THE HEIGHTS AT STONE OAK
PLANNED OVERALL AREA DEVELOPMENT PLAN (POADP)

PRELIMINARY OVERALL AREA DEVELOPMENT PLAN (POADP)
THE HEIGHTS AT STONE OAK II #358 – C

Re: The Heights at Stone Oaks POADP # 358 - C

SUBJECT: The Heights At Stone Oak, POADP #358 & #358C Level II T.I.A.

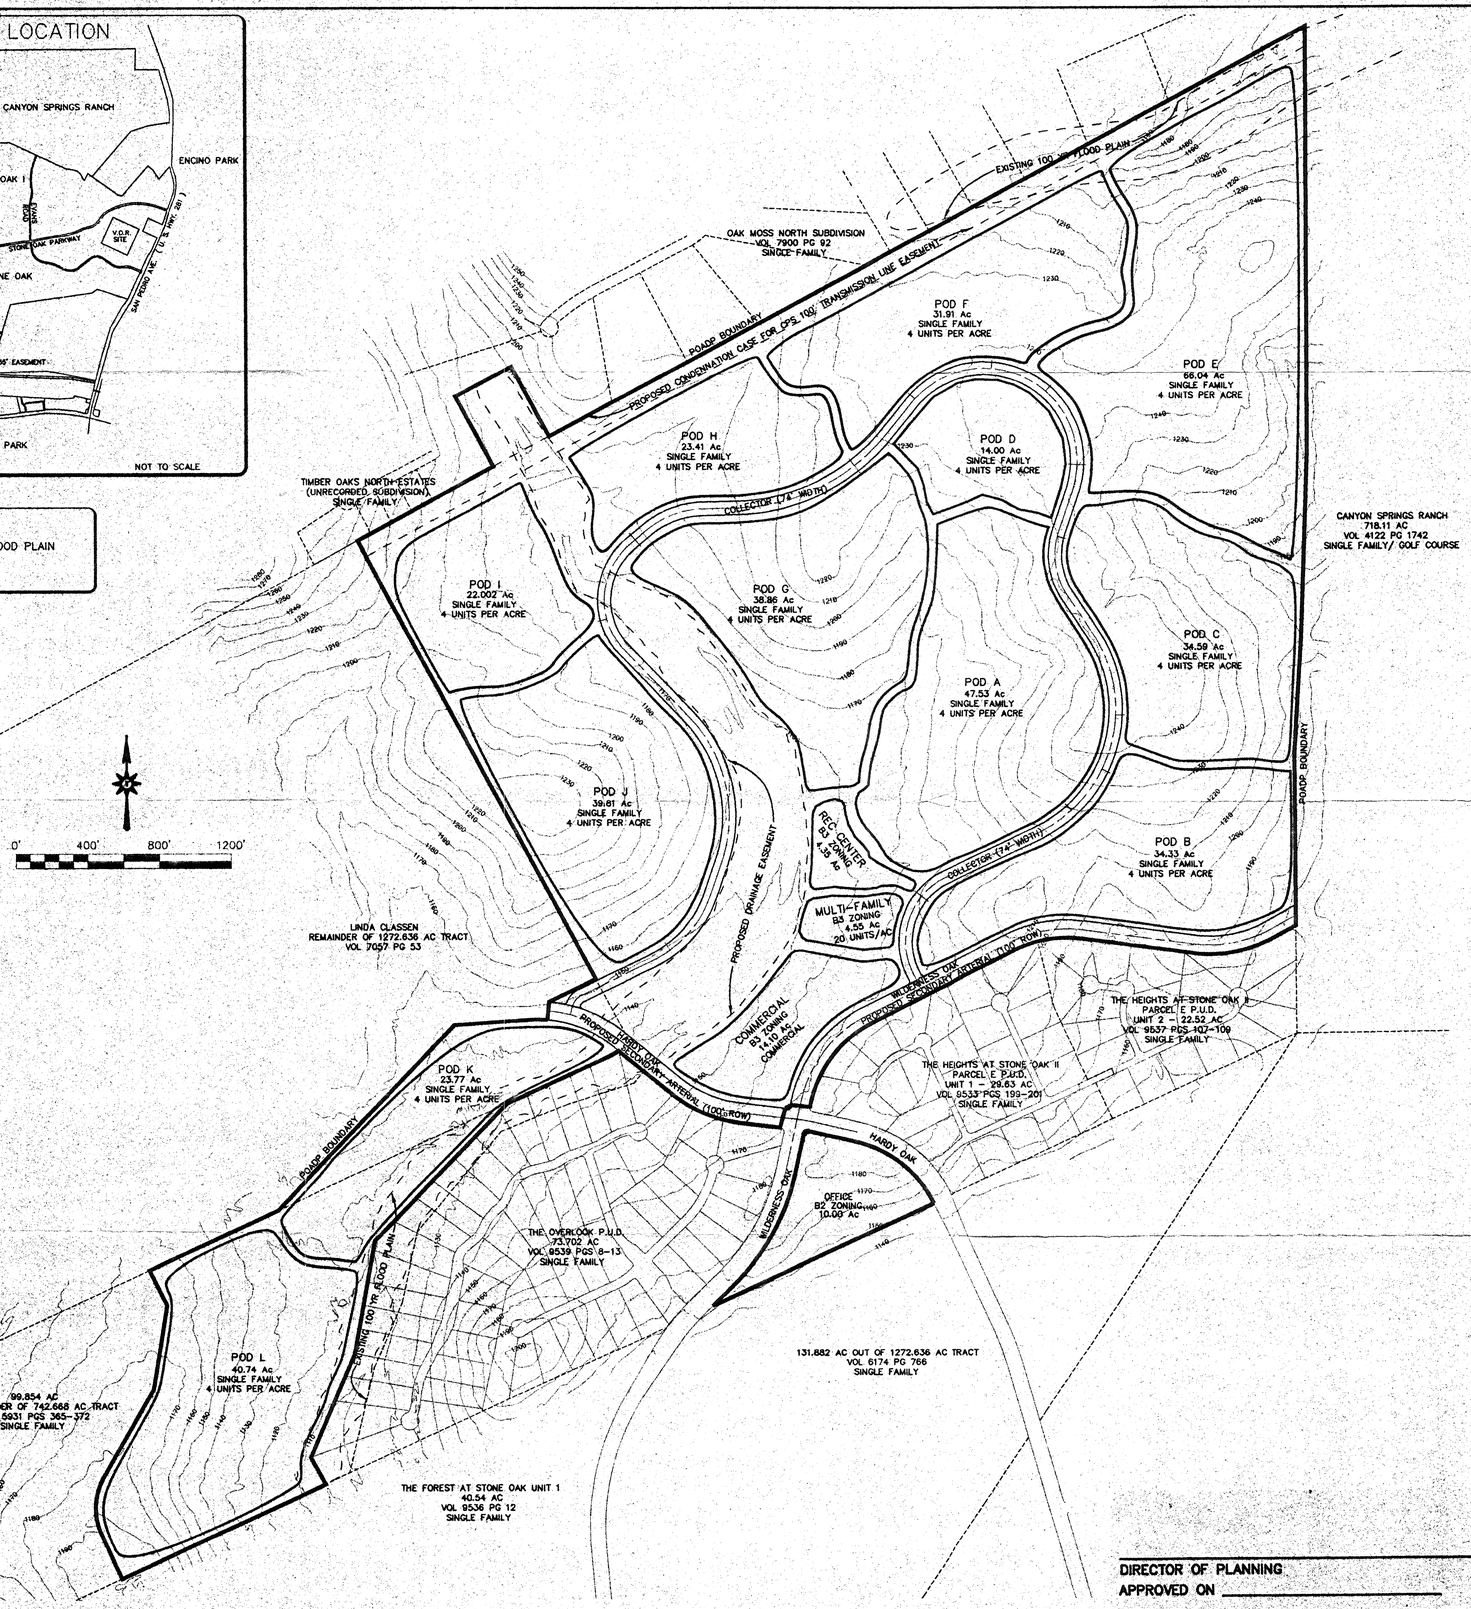
The City Staff Development Review Committee has reviewed The Heights at Stone Oaks Subdivision Preliminary Overall Area Development Plan # 358 - C. Please find enclosed a signed copy for your files. Although your plan was accepted, please note the following:

- Based on the topography, a Flood Plain Study and drainage review will probably be required during the platting process.
- In consideration of public safety and convenience, excessive grades by reason of topography should be avoided in street layouts and arrangements.

- This development will probably need to conform to requirements associated with development over the Edwards Aquifer. For additional information about these requirements you can contact SAWS at 704-7305.

- Staff recommends that there be no residential frontage on all collector streets.
- This development will need to comply with tree preservation ordinance #85262. For additional information about these requirements you can contact Building Inspections at 207-7102.

- It will be expected that you will plat all of the property depicted in your POADP, to include: floodpains, drainage areas and open space.
- I would like to encourage you to work closely with the school district, so that they can plan accordingly.
